INDUSTRIAL PARK COMMISSION

AGENDA

To: Industrial Park Commission
From: Joe Stephenson
Date: 02-10-2022
Re: Site Plan Review – Velocity Water Expansion – 100 Kelso Road

To: Industrial Park Commission
From: Joe Stephenson
Date: 02-10-2022
Re: Site Plan Review – TANN Corporation – Oak Grove Road

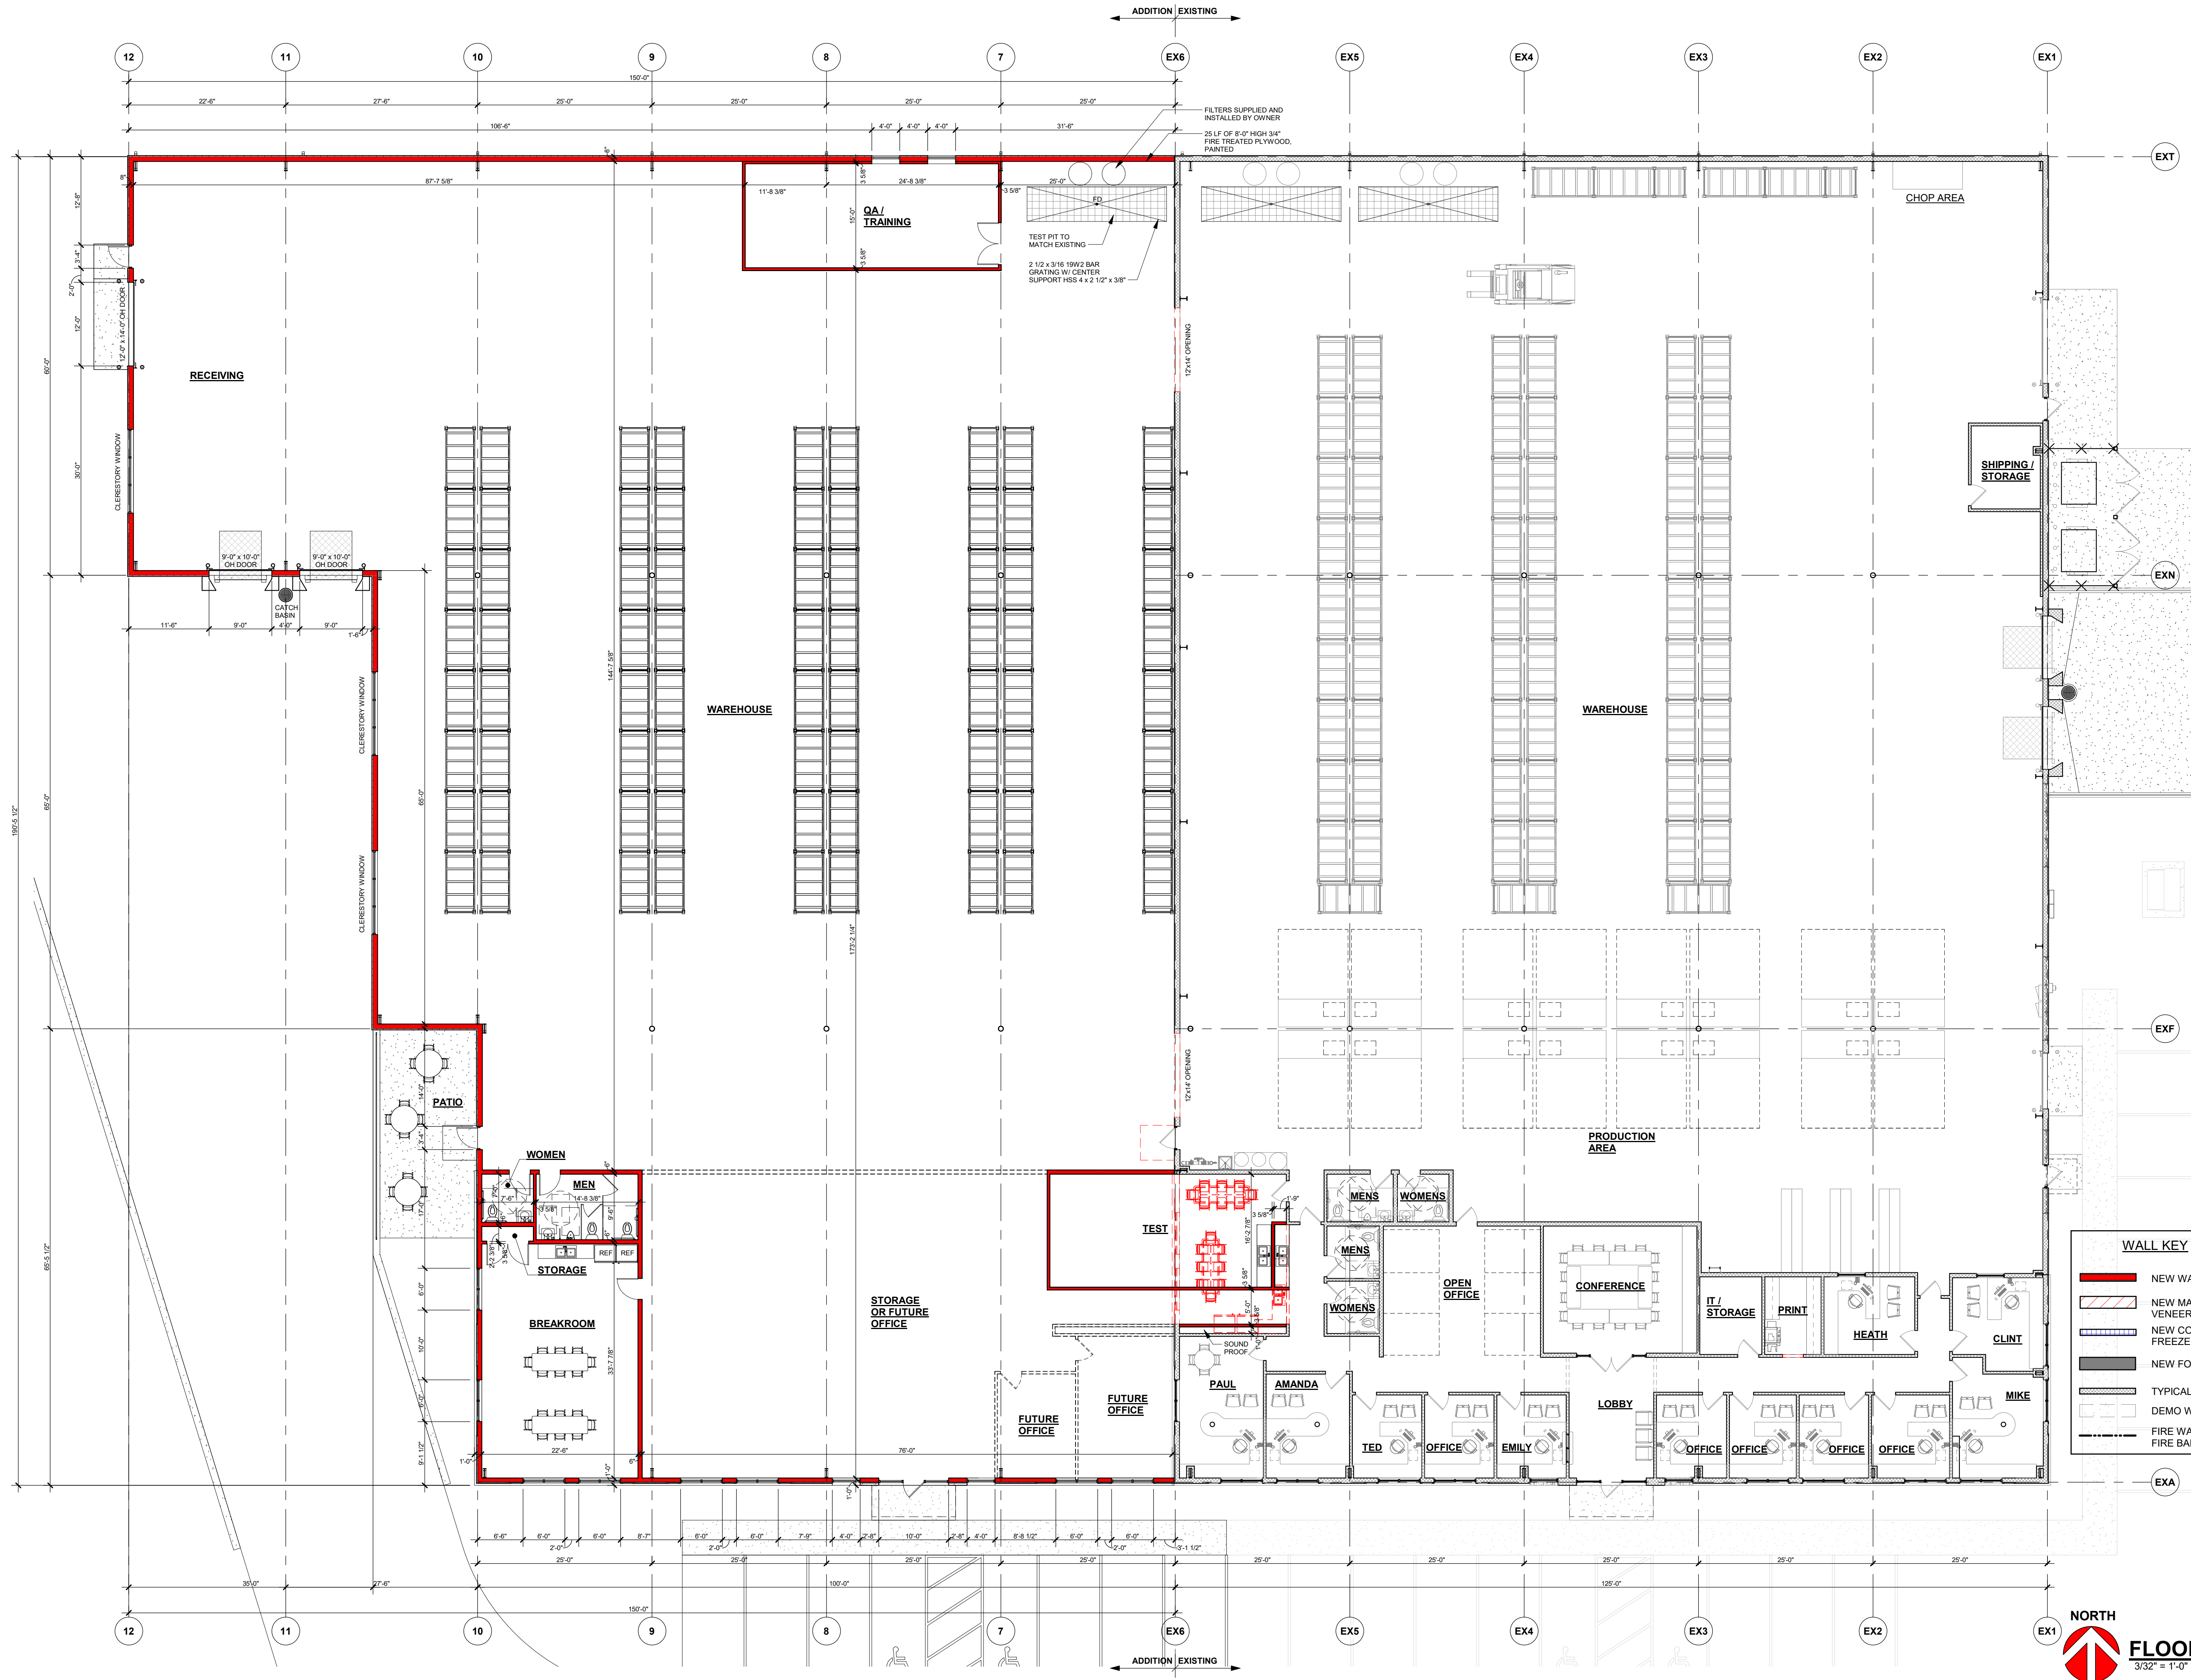
Keller Inc, on behalf of the property owners, has submitted a site plan review for the expansion of the Velocity Water Facility, located at 100 Kelso Road (New Prosperity Industrial Park). The applicant is proposing a 23,671 square foot expansion that will double the size of the existing build. The addition will include two truck bays, an employee patio, additional warehousing space, breakroom, and additional bathroom space. In addition, the applicant will be expanding their parking/drive aisle to improve traffic flow and accommodate increased parking needs.

The expansion will look like the existing facility, with decorative split face, LP Smart siding, and EIFS being used throughout.

The site is zoned Industrial Park (IPD). With adjacent uses being Agriculture to the south, IPD to the north and east, and institutional (cemetery) to the west.

Landscaping requirements have been met. Greenspace and building density meet code. All parking requirements have been met, with 34 off street parking stalls. The total height of the building is 25' 9" (at the high side eave).

Approval of the Site Plan for Velocity Water 100 Kelso Road, allowing an expansion of the existing facility.

**REI**
REI No. 9874
SHEET C100

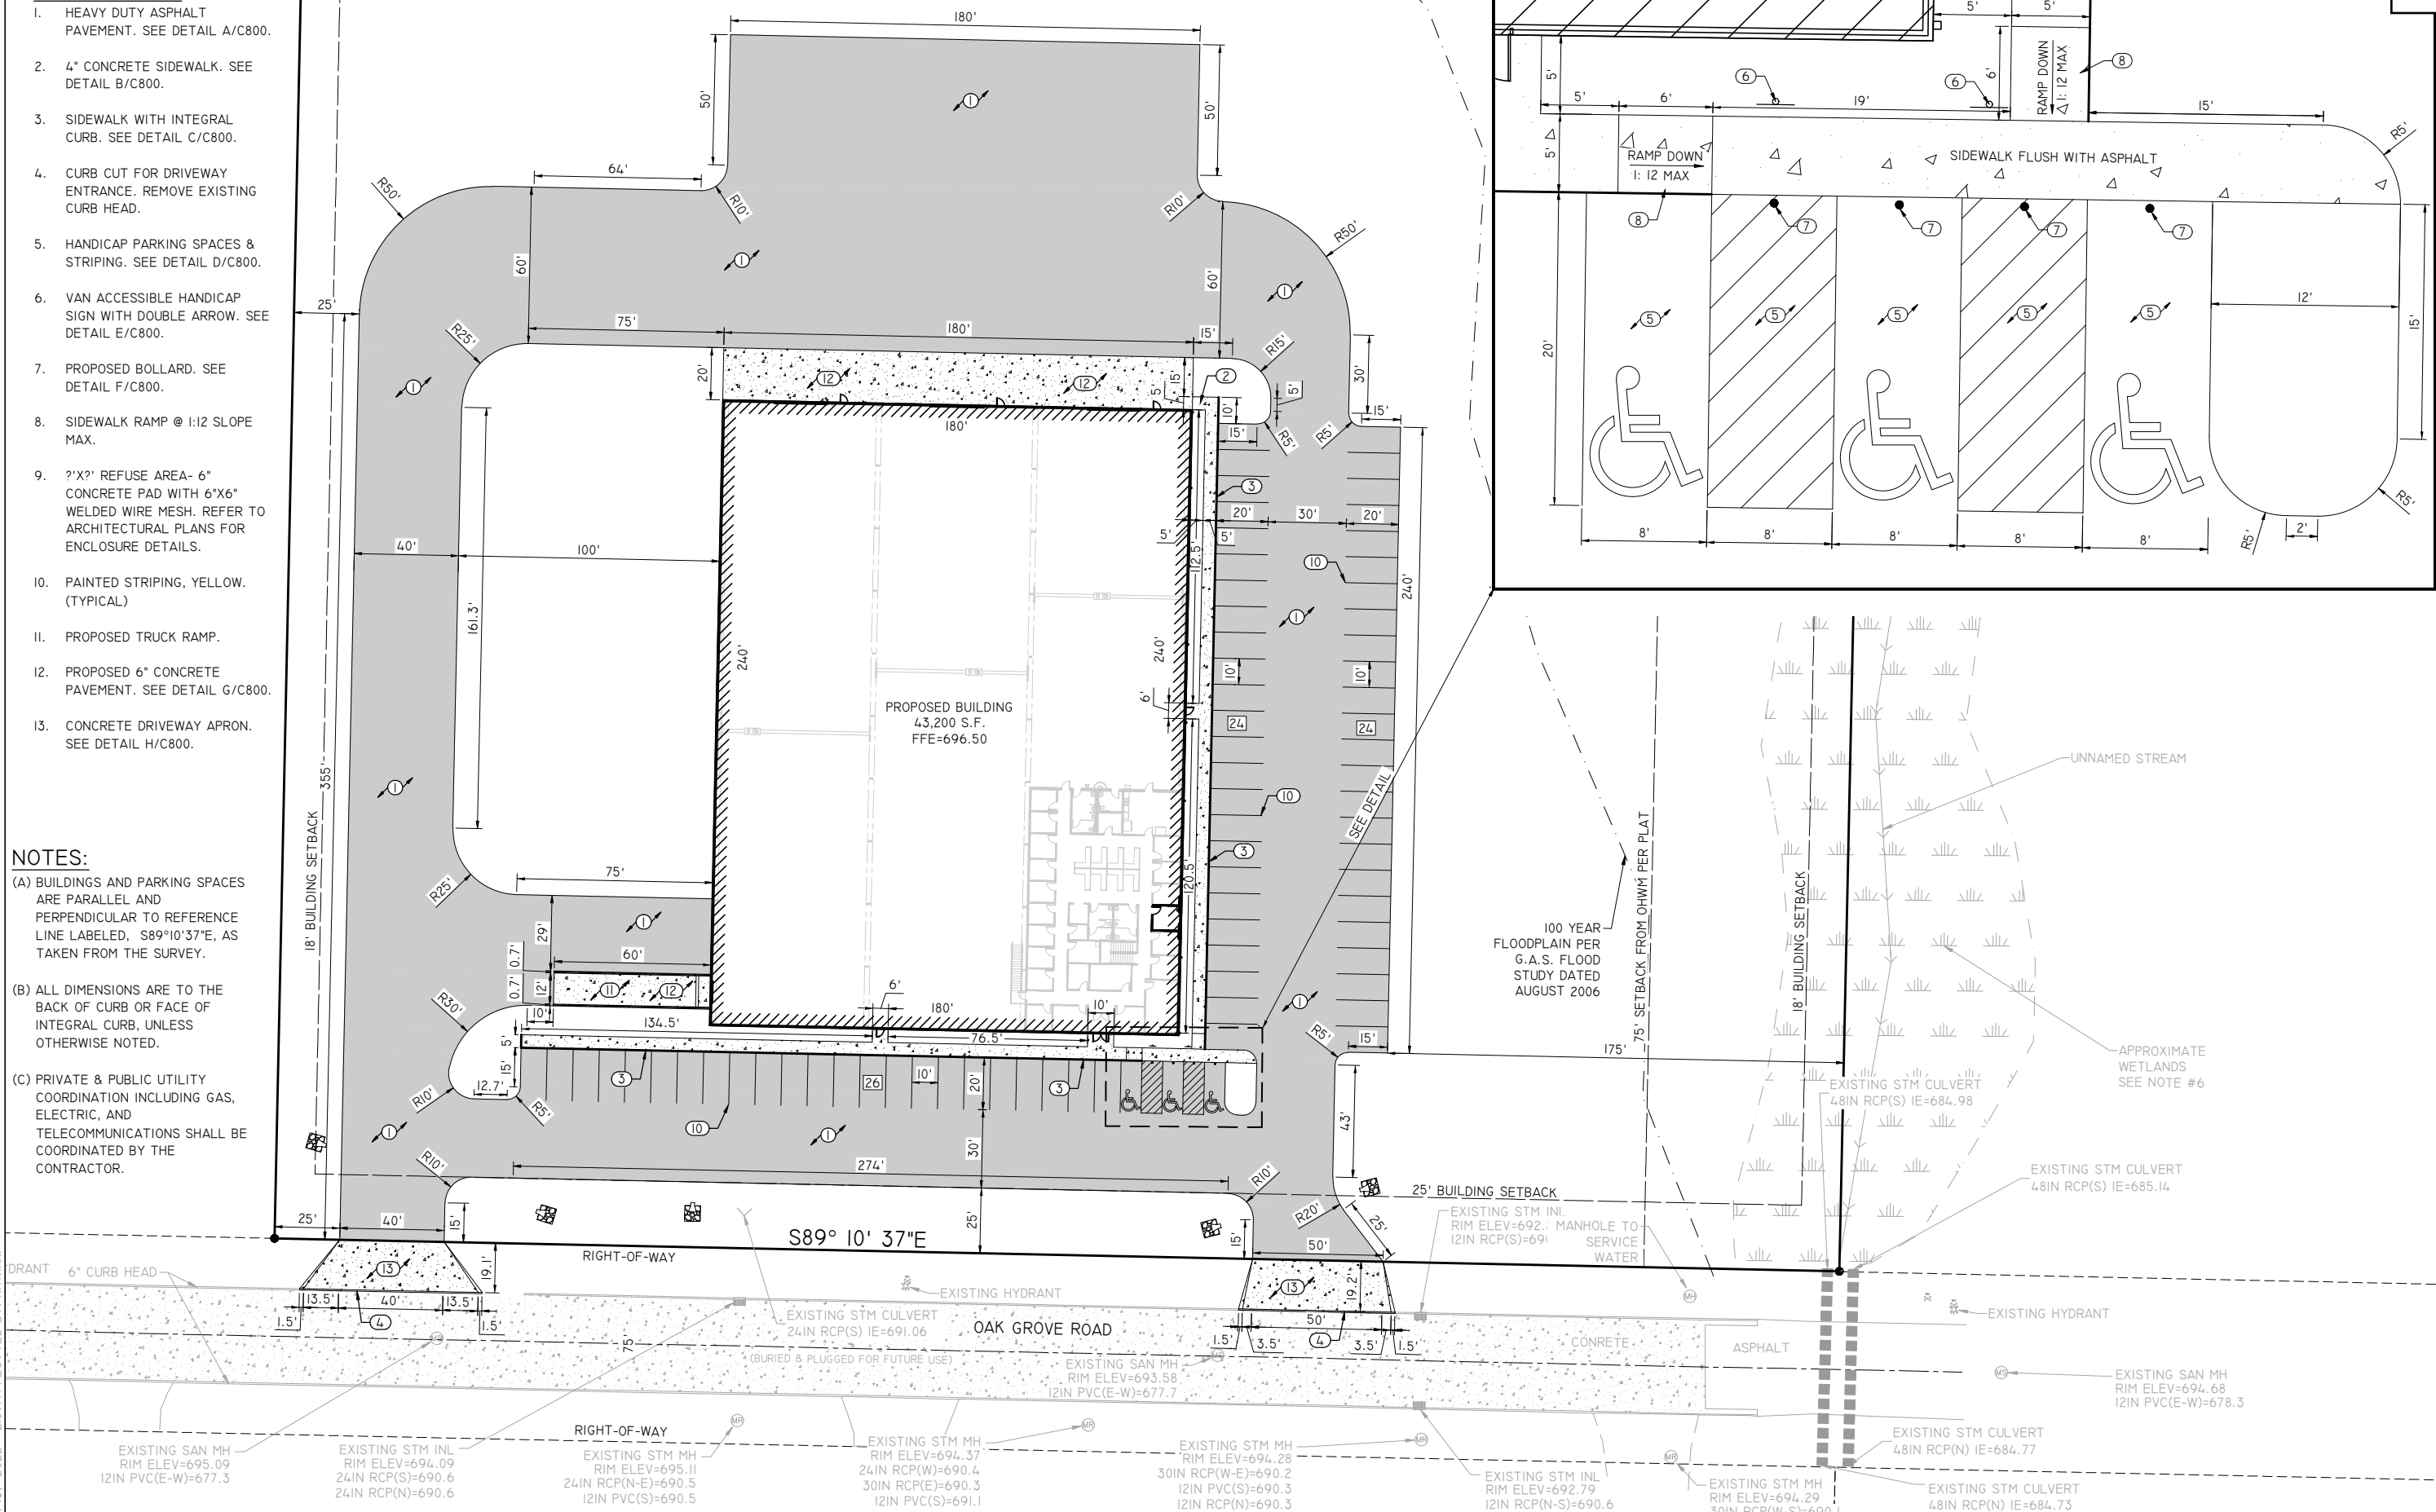
Per New Prosperity Center Covenants, 11 shade trees are required on this property or planted at Van Epern Park in lieu of onsite plantings. The applicant has committed to either planting these trees on site or planting trees in Van Epern Park. The decision on where these trees will be placed is still forthcoming. Greenspace and building density meet code. All parking requirements have been met, with 74 off street parking stalls. The total height of the building is 43' 7.5" (at the high side eave).

- A stormwater management plan is submitted to and approved by the department of public works, prior to building permits issuance.
- Shade tree requirements are met, per New Prosperity Center Covenants, and approved by staff prior to building permit being issuance.
